IKEGAMI TECHNICAL

BULLETIN

Product: HTM-2050RA1, HTM-2050R2

Subject: Recommended Modification to Def. Board and HV out board

DEF
BOARD

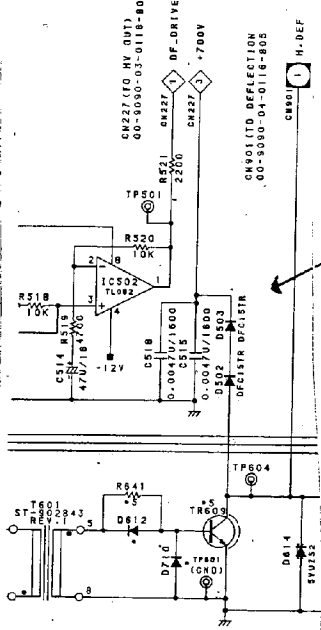
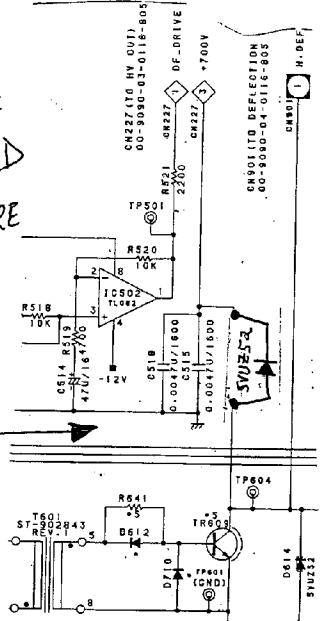
Operating in areas of high ambient temperature it is possible for D-502 or D-503 on the Def. Board to overheat and fail.

Modification Procedure: It will be necessary to remove the monitor covers and remove both the deflection and HV OUT boards. On the Def. Board mount a new diode to the bottom of large heat sync located on the deflection board. The new diode will be located below TR-607 and mounted in similar fashion to D-614 above TR-607. There is a screw hole already on the heat sync.

1. Remove Diodes D-502 and D-503 (DFC15TR)
2. Add Diode 5VUZ52 and mount it to heat sync below TR-607 (described above)
3. Add insulated jumper wire from 5VUZ52 anode to anode hole of removed D-502
4. Add insulated jumper wire from 5VUZ52 cathode to cathode hole of removed D-503

USE
EXISTING
HOLE

NEW
DIODE
5YU252

ON THE HV OUT BOARD

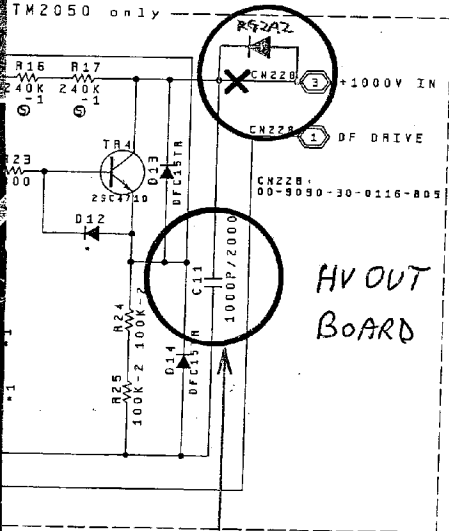
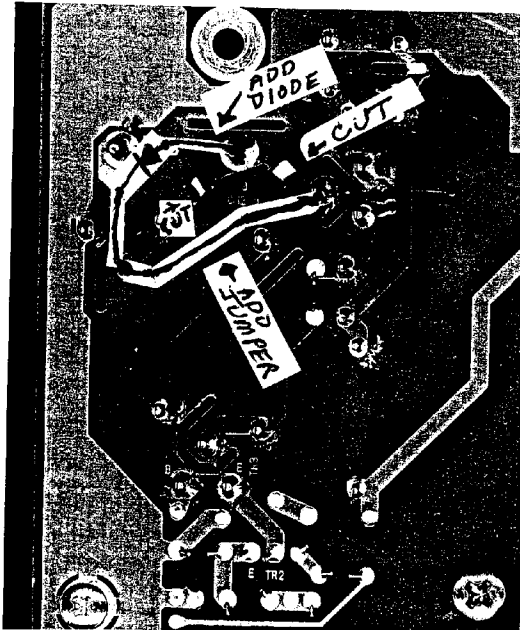
1. Replace C-11 1000p / 2kV with part number DE1207R102K
2. Locate pin 3 of CN-228, on the trace side, cut trace on both sides of pin 3 to isolate it.
3. Add insulated jumper wire from C-11 (side that was isolated by pin 3 cut) to Collector of TR4 (isolated by other pin 3 cut)
4. Add diode RG2A2, Cathode to C-11 (side that was isolated by pin 3 cut) Anode to pin 3.

REPLACE WITH
DE1207R102K
